Re: FortisBC Energy Inc. (FEI)

Application for a Certificate of Public Convenience and Necessity (CPCN) for the Tilbury Liquefied Natural Gas Storage Expansion (TLSE) Project (Application)

Response to My Sea to Sky (MS2S) Information Request (IR) No. 5

Figure 1-2: PwC Economic Harm Calculation for Winter T-South No-Flow Event (Low, Median, High)³³

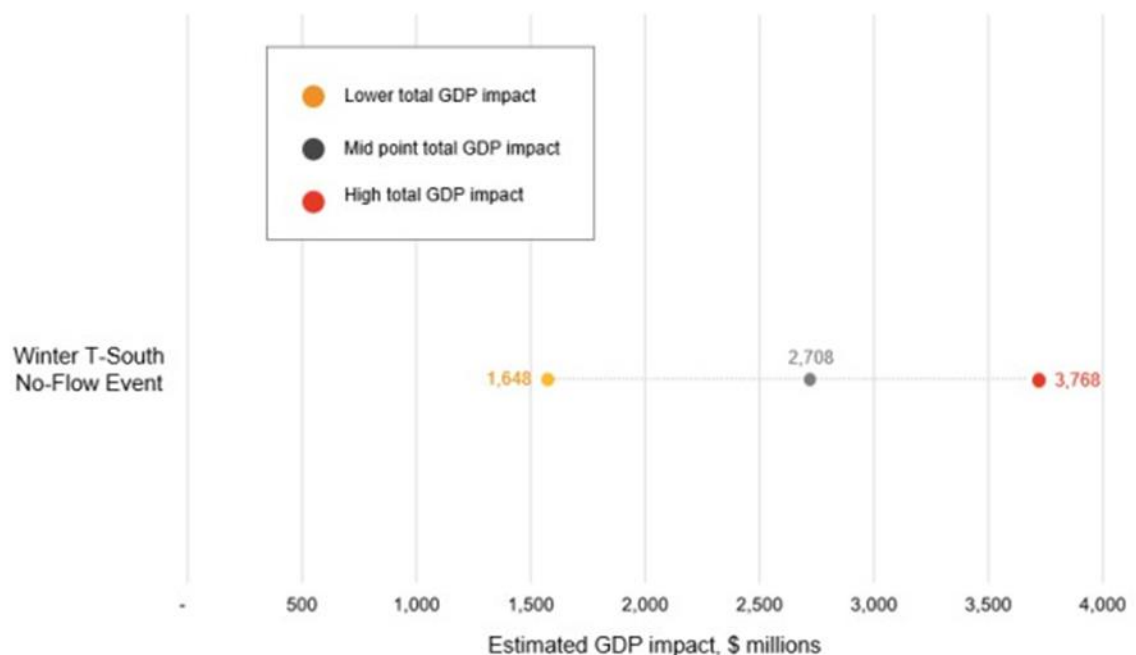
3 **Figure 1-2 (page 10) of TLSE Exhibit B-60** (reproduced below) shows a mid-point
4 economic (GDP) loss of \$2.71 Billion, with lower and higher bounds of \$1.648 Billion and
5 \$3.768 Billion, respectively.

1.3 As the economic losses estimated are those that would be avoidable with the approval and construction of the TLSE project, should the midpoint be closer to \$191.5 million in avoidable potential loss (PwC's \$2.708 billion estimate pro-rated based on the amount of time the TLSE project could satisfy demand in the event of a no-flow incident)?³

1.3.1 As \$191.5 million is significantly less than the proposed cost of the TLSE storage tank (estimated at over \$873 Million⁴), can FEI clarify its statement at **pages 9 and 53 of TLSE Exhibit B-60** (that a no-flow event would cause "catastrophic economic harm well in excess of the cost of the Preferred Alternative")?

Please refer to the response to MS2S IR5 1.1. The avoided potential loss would be prorated based on the amount of time the TLSE Project satisfies demand in the event of a no-flow incident only in cases where repairs are not completed prior to depleting the resilience supply. In cases where repairs are completed prior to exhausting the resilience supply (or a regulatory shutdown period ends, for parallel pipes where only one fails), the avoided losses should not be prorated, as the TLSE Project prevents long duration outages that would otherwise occur without the TLSE. Exponent's analysis accounts for the probability out the TLSE depleting its resilience supply prior to completion of repairs or the end of a regulatory shutdown period.

FEI's statement referenced in MS2S IR5 1.3.1 does not need to be clarified as the Question is based on an incorrect premise.
